CERTIFICATE OF APPROPRIATENESS

Property: 540 Frasier Street, Tracts 1 & 2, Block 1, Freeland Subdivision. The property includes a historic 1,870 square foot, one and a half-story wood frame single-family residence and a detached garage situated on a 5,000 square foot (50' x 100') corner lot.

Proposal: Alteration – Siding and windows

Attachment A

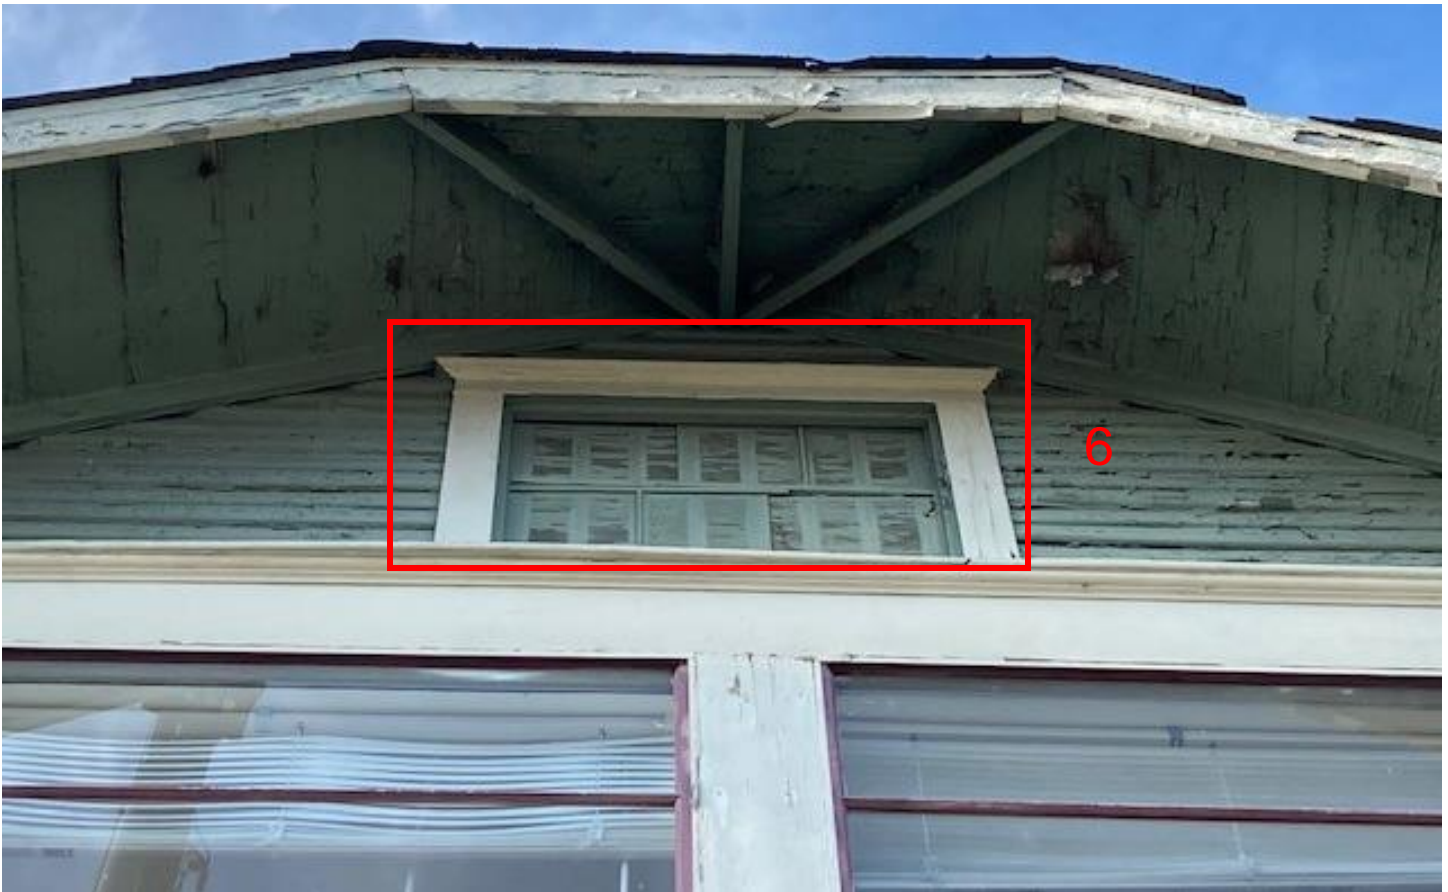
Upper-floor windows altered from side-by-side to a single window.

Broken window in lower-left of picture.

7

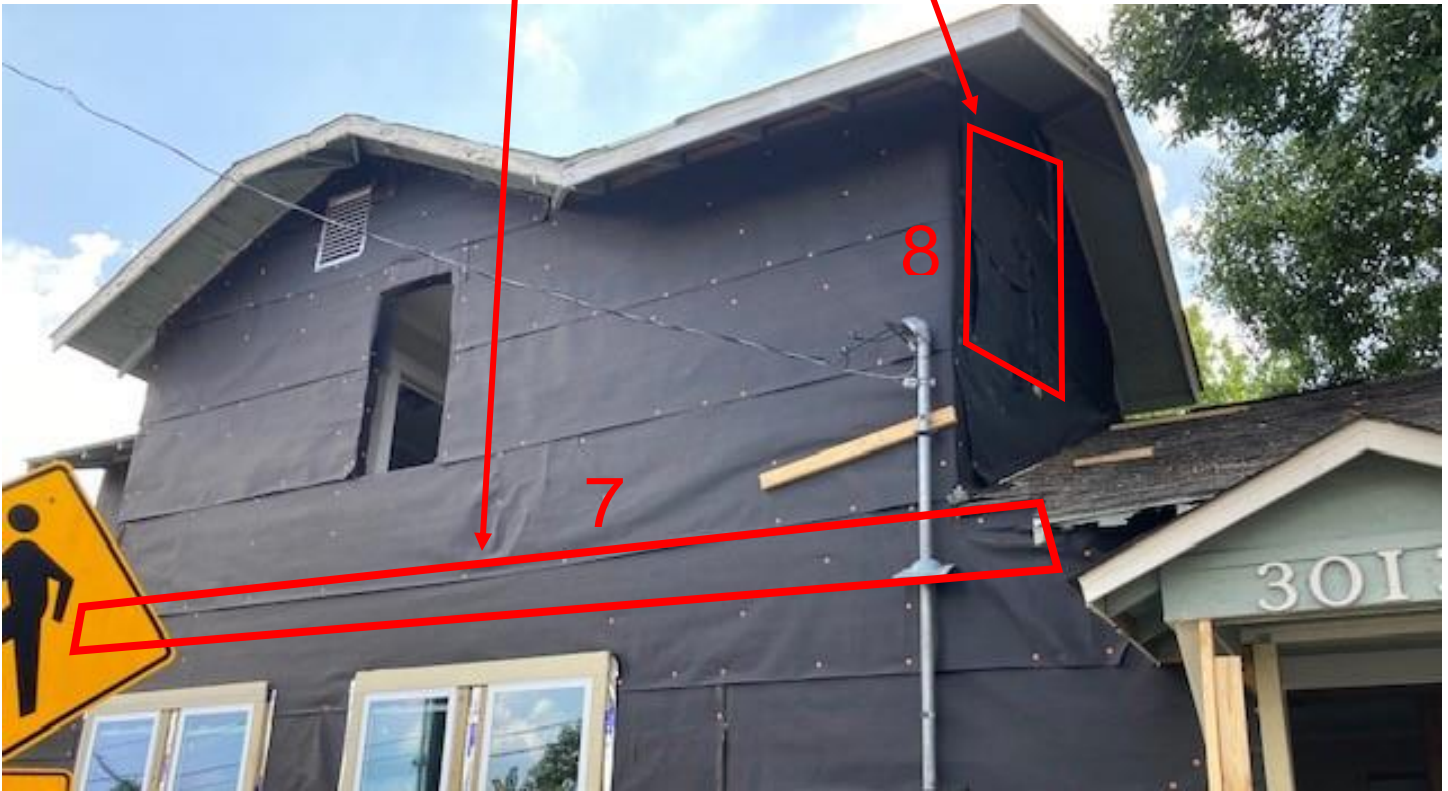
Existing roof joist damage along eave prior to unpermitted work that removed the eave facing White Oak Drive.

Existing roof joist damage along eave prior to unpermitted work that removed the eave facing White Oak Drive.

10

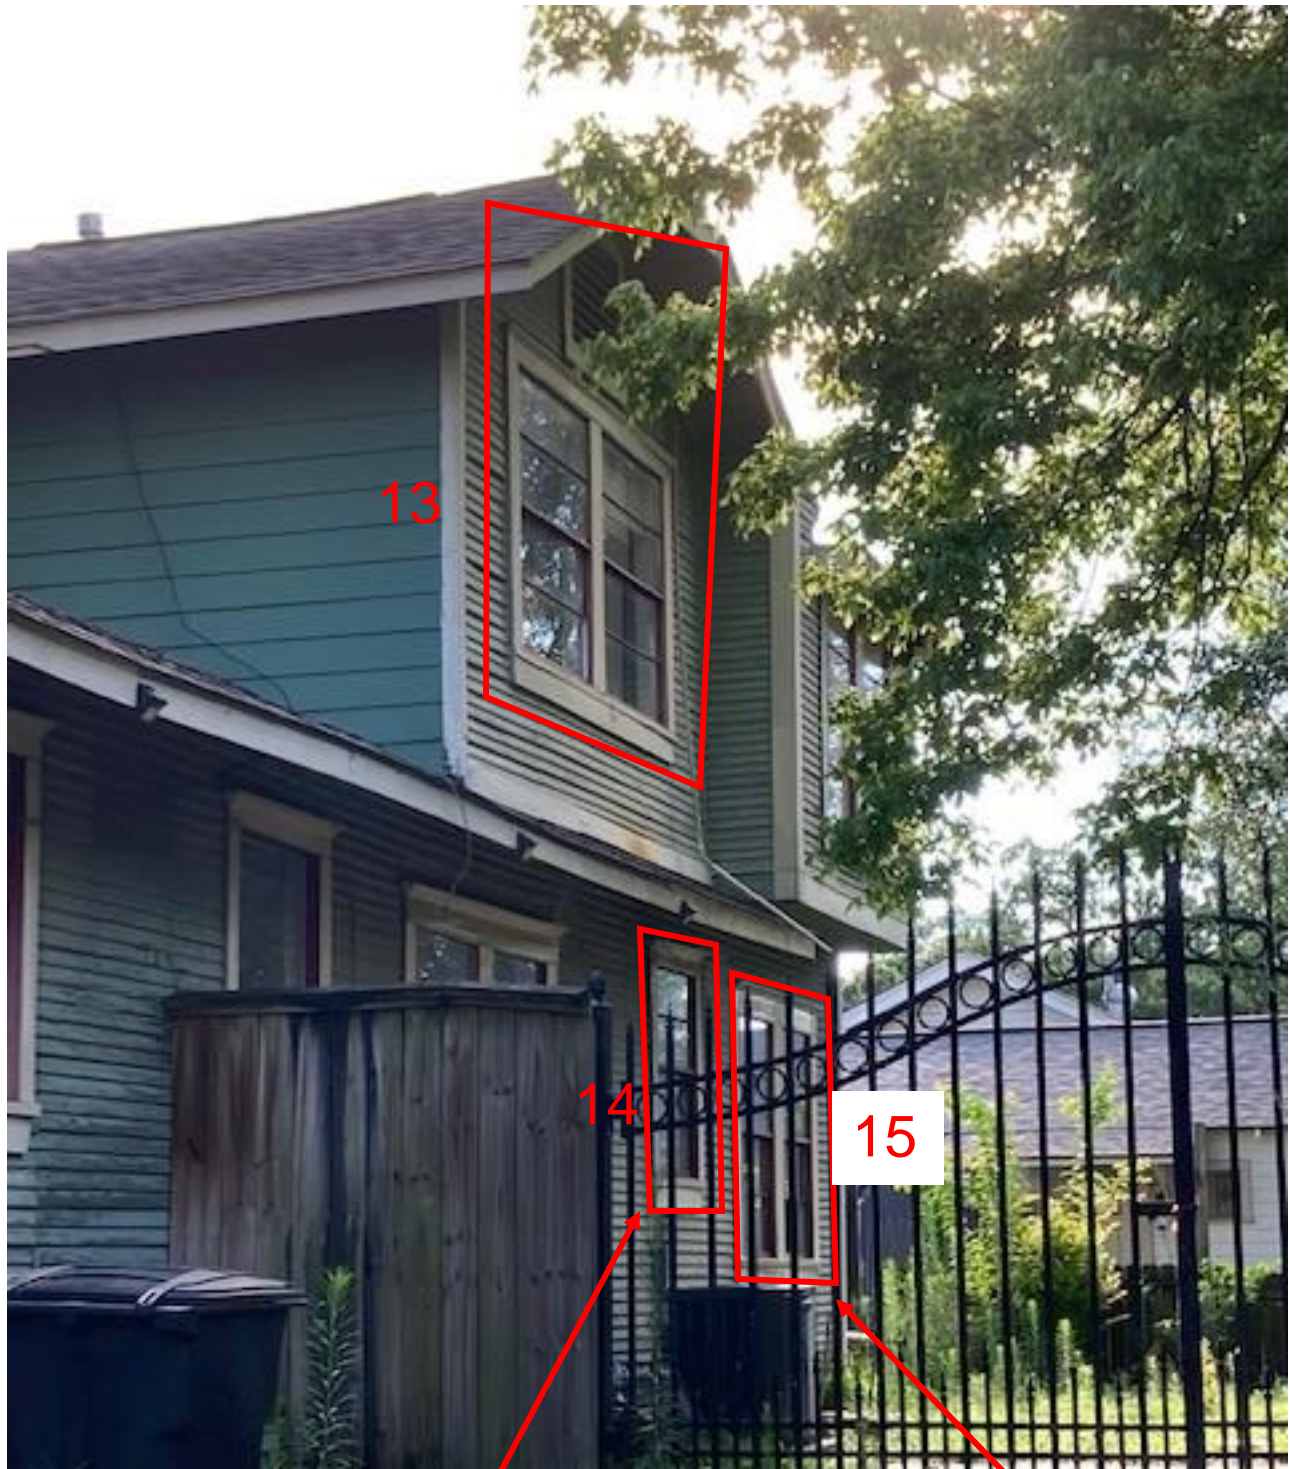
A window removed and replaced with a door opening. A portion of the eave removed.

Window profiles are not inset and recessed.
